香港城市規劃委員會依據城市規劃條例擬備的將軍澳分區計劃大綱圖
TOWN PLANNING ORDINANCE, HONG KONG TOWN PLANNING BOARD
TSEUNG KWAN O - OUTLINE ZONING PLAN

核准圖編號 S / T K O / 2 8 的修訂
AMENDMENTS TO APPROVED PLAN No. S/TKO/28

APPROVED DRAFT TSEUNG KWAN O OUTLINE ZONING PLAN NO. S/TKO/28A

Title: Existing/ Proposed Sewerage System in the Vicinity of the Application Site

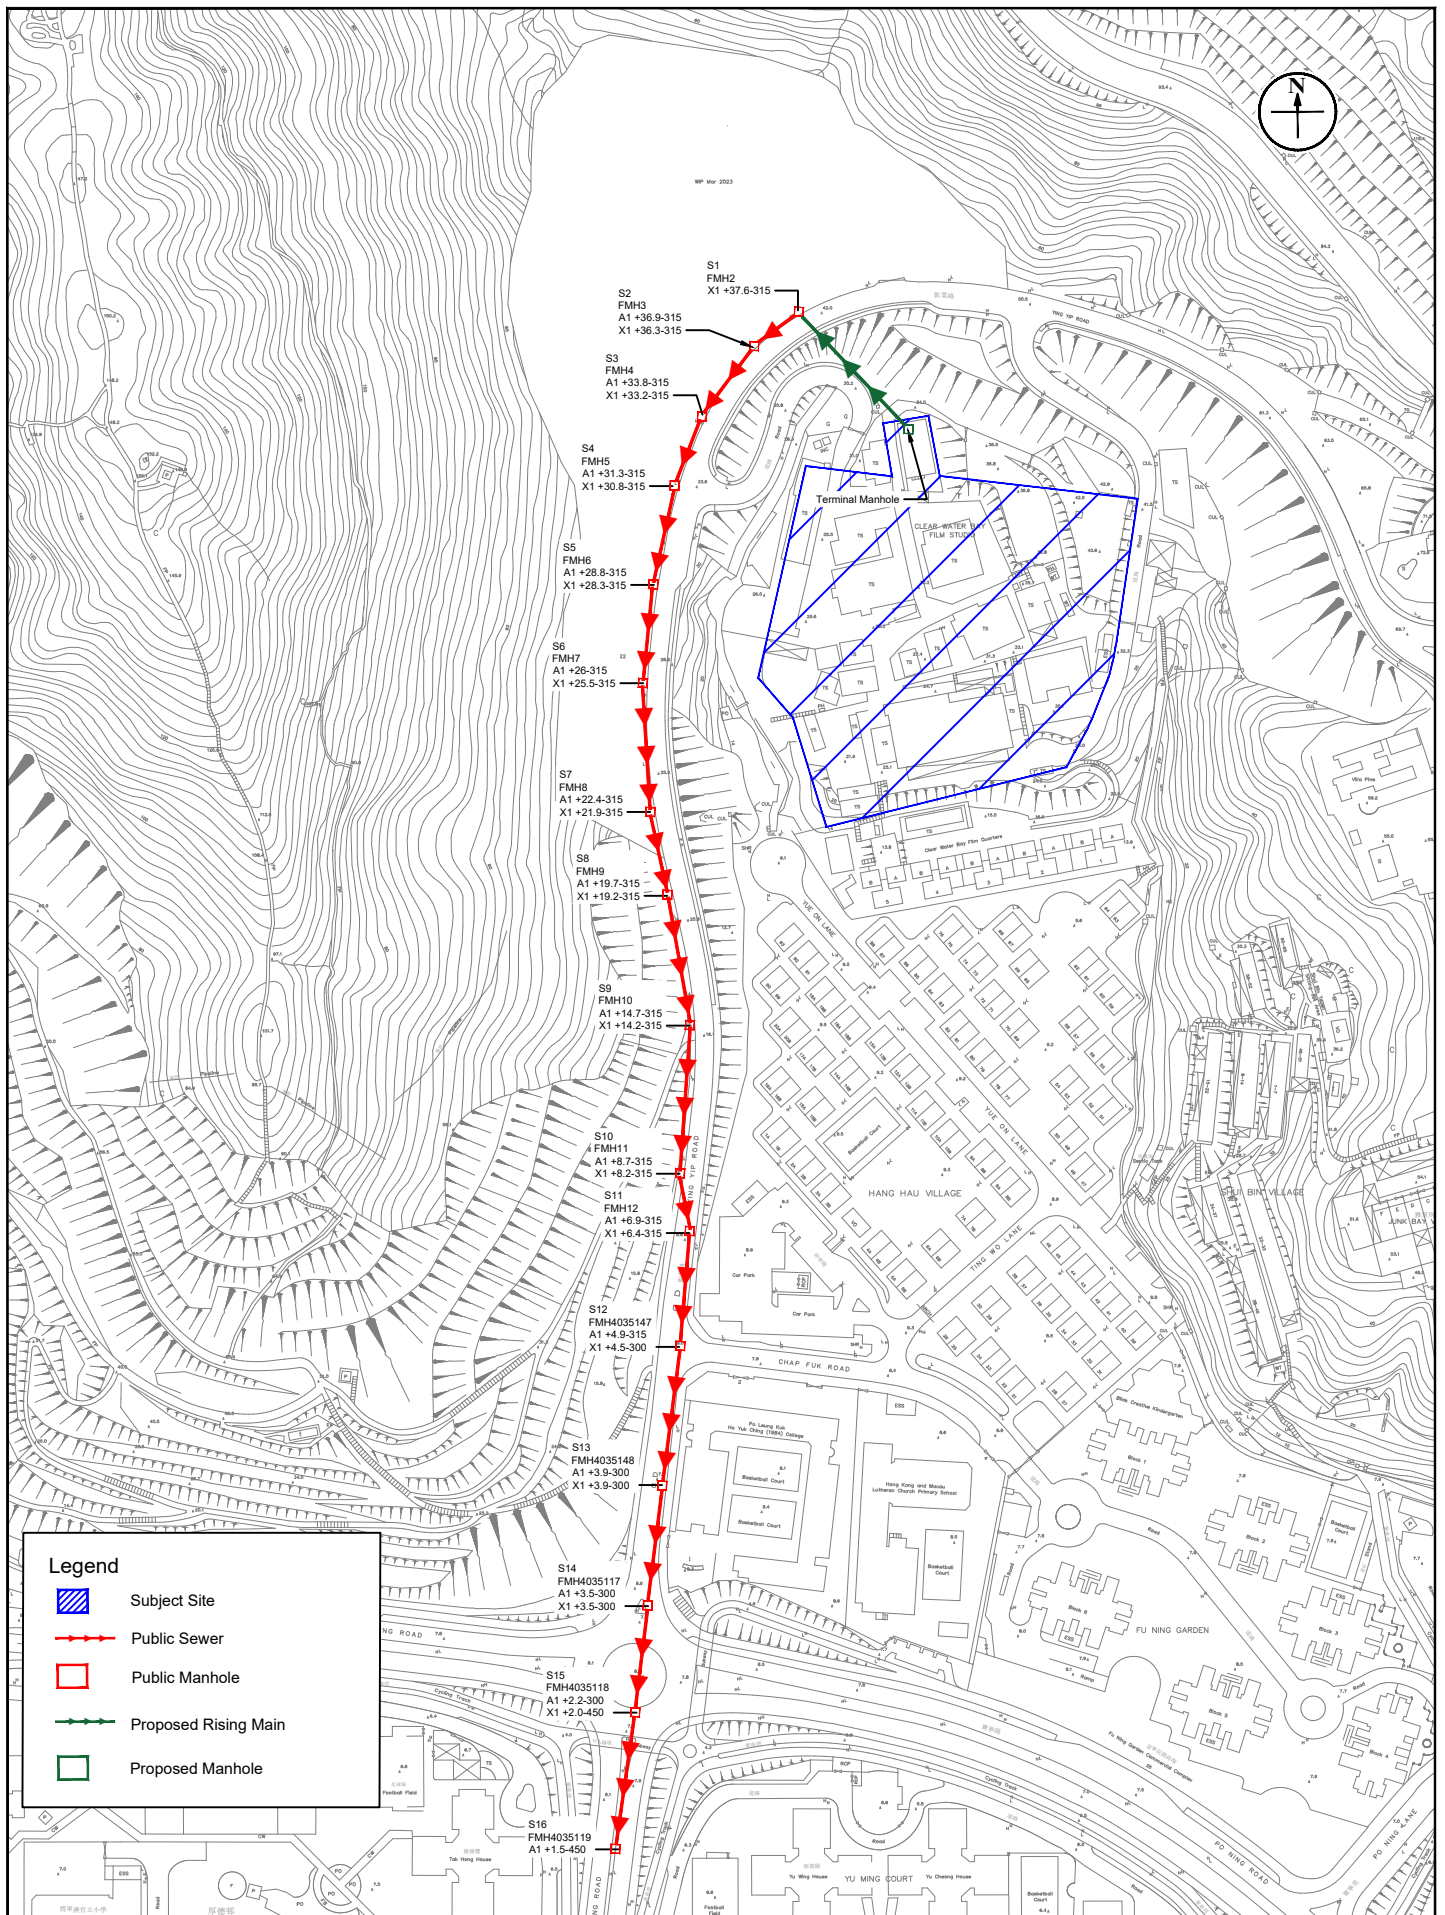
| Department | Comment(s) | Consultant's Response |
|--------------------------|---|--|
| | Para 2.5.1 & Figure 2 - The sewerage generated from the proposed development will be conveyed to the existing manhole (FMH4035156). The proposed sewer alignment would be across the existing Box Culvert SBP4006161. Please review the level difference to avoid direct conflict with the existing underground utilities. Our drainage record plan is attached for easy reference (Appendix I) | The sewage generated from the proposed development will be discharged to the new sewer (manhole FMH2) along Ying Yip Road via rising mains from the terminal manhole at the north of the proposed development. |
| | Figure 2 - The terminal manholes shall be within the lot boundary of the proposed development. | Noted. |

| Department | Comment(s) | Consultant's Response |
|--------------------------|--|--|
| | 3. Figure 2.1 - It is observed that the proposed sewage connection to the existing sewerage system and 3 Manholes immediate downstream are not labeled. Please review and clarify. | The labels shown in Figure 2.1 are already updated in SIA v1.4. |

Title: Existing/ Proposed Sewerage System and Catchments Area in the Vicinity of the Application Site

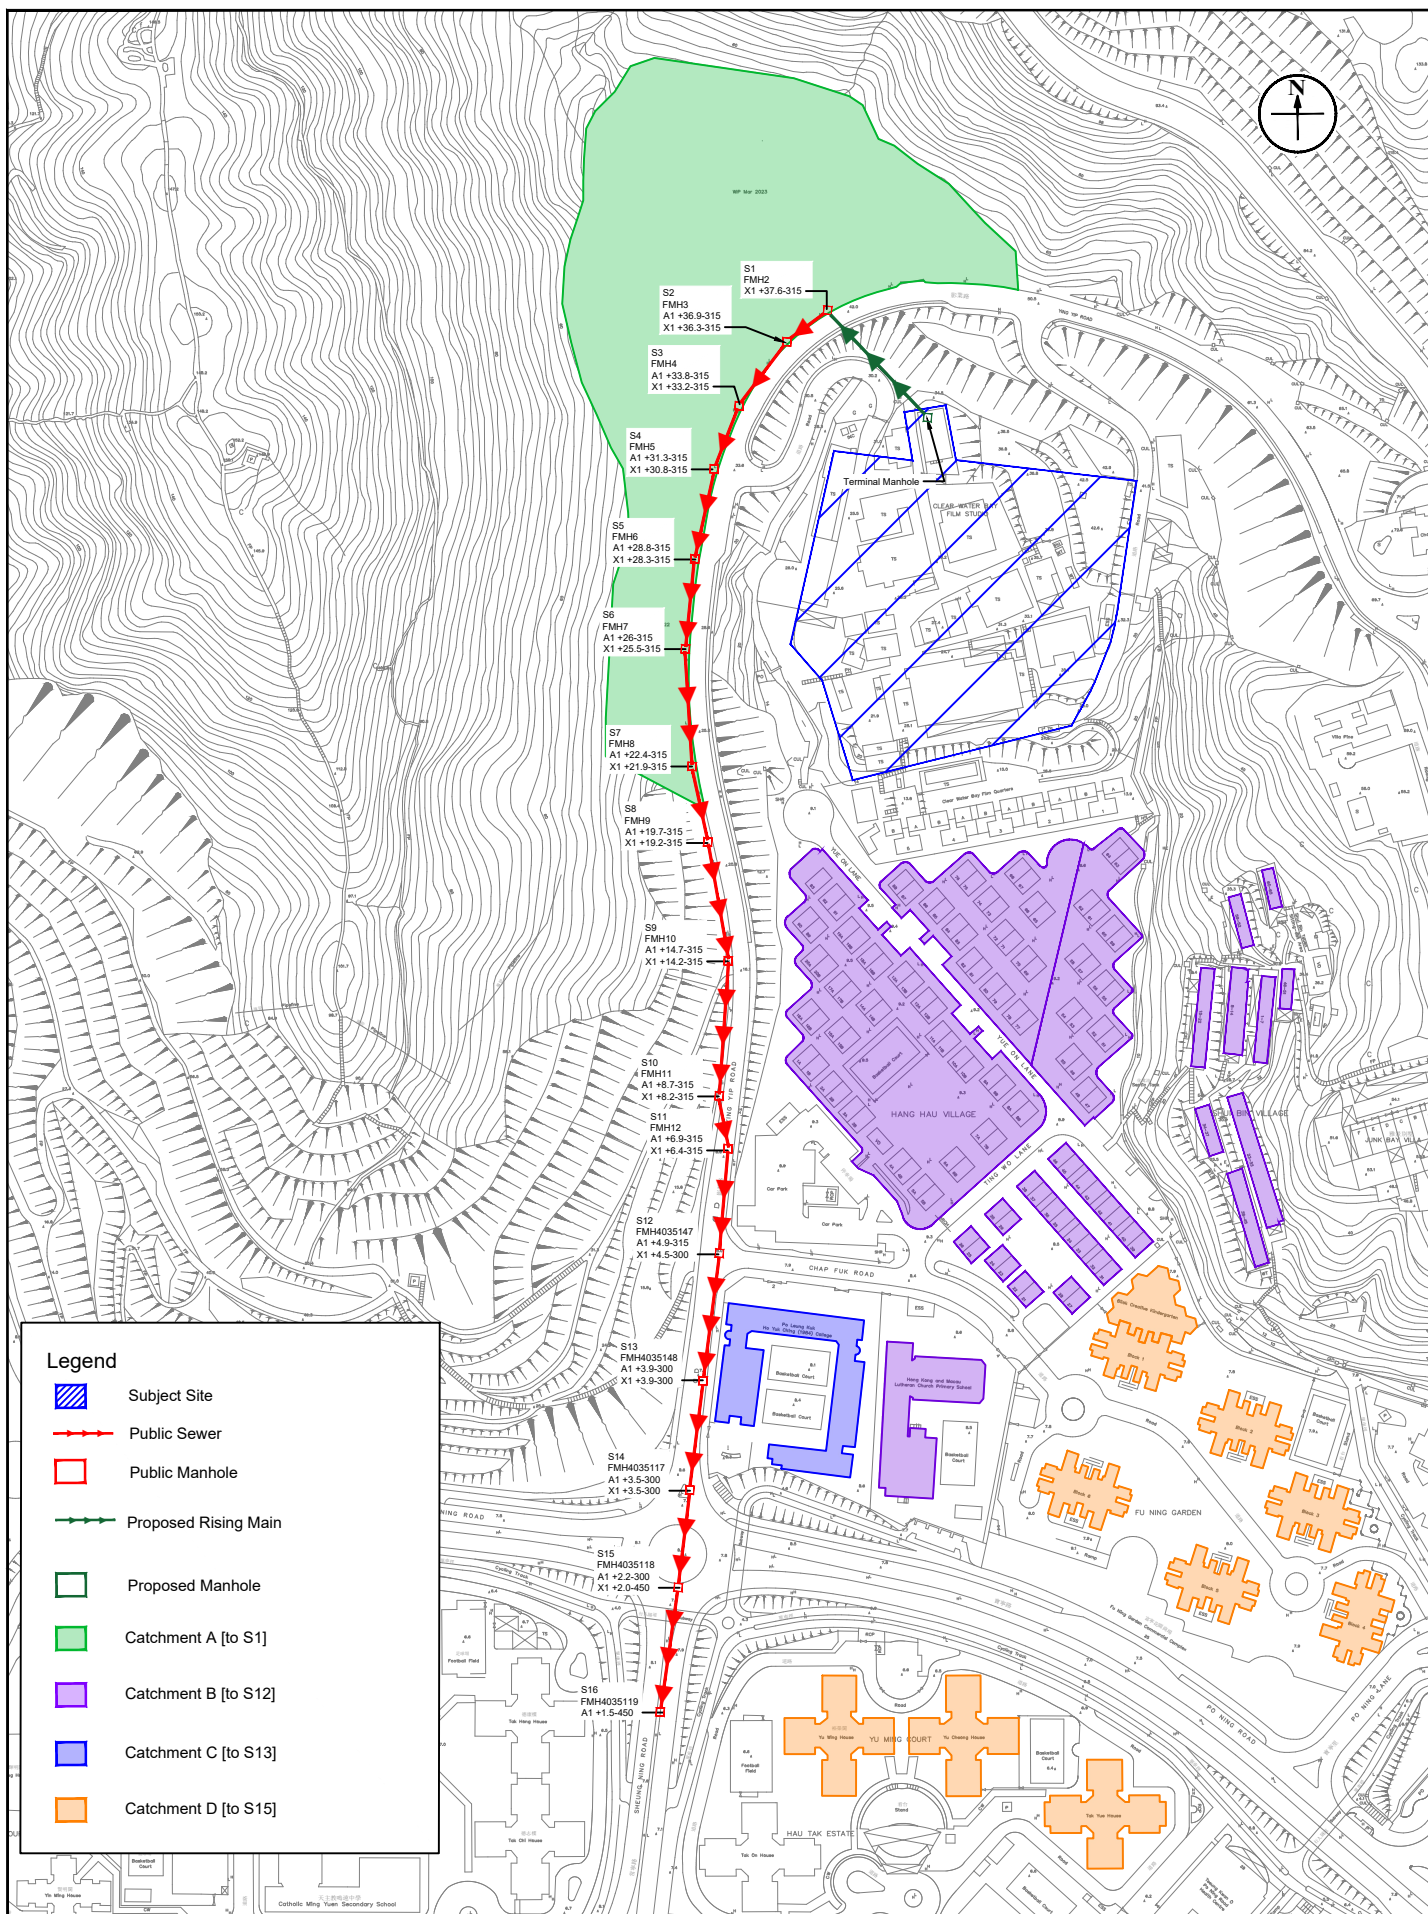
| Department | Comment(s) | Consultant's Response |
|--------------------------|---|--|
| Comments from DSD | Figure 2.2 - Please clarify about the consideration of sewage flow from Clear Water Bay Film Quarters which should be within the sewerage catchment. | The sewage from Clear Water Bay Film Quarters is treated by its on-site septic tank. Therefore, it is not considered in the sewerage catchment. |
